## ***Interactive comment on “Evaluation of improved land use and canopy representation in BEIS v3.61 with biogenic VOC measurements in California” by J. O. Bash et al.***

Received and published: 16 March 2016

**Fig. 1.** Difference between the BELD 4 total above ground biomass (Mg/ha) and the estimates of Blackard et al. (2008)

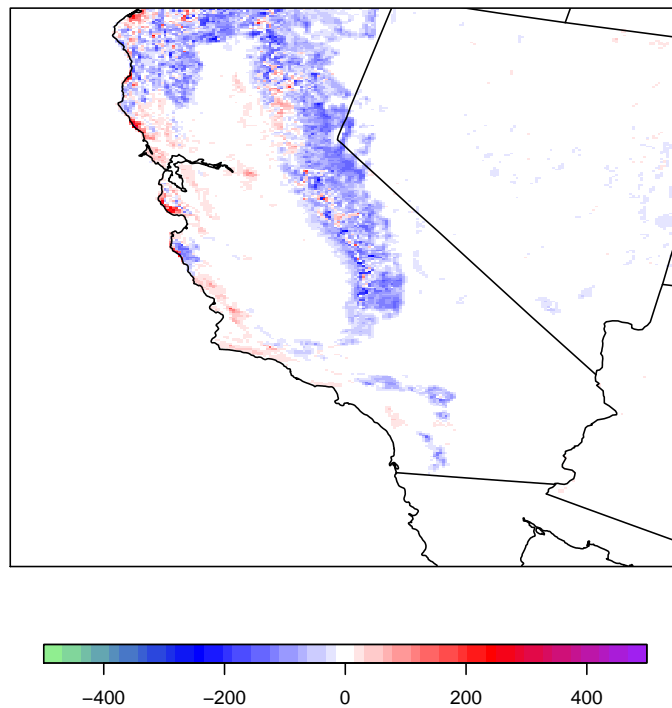
7. Figure 2. Could you add a difference plot for clarity?

A difference plot was added to figure 2 (see Figure 1 below).
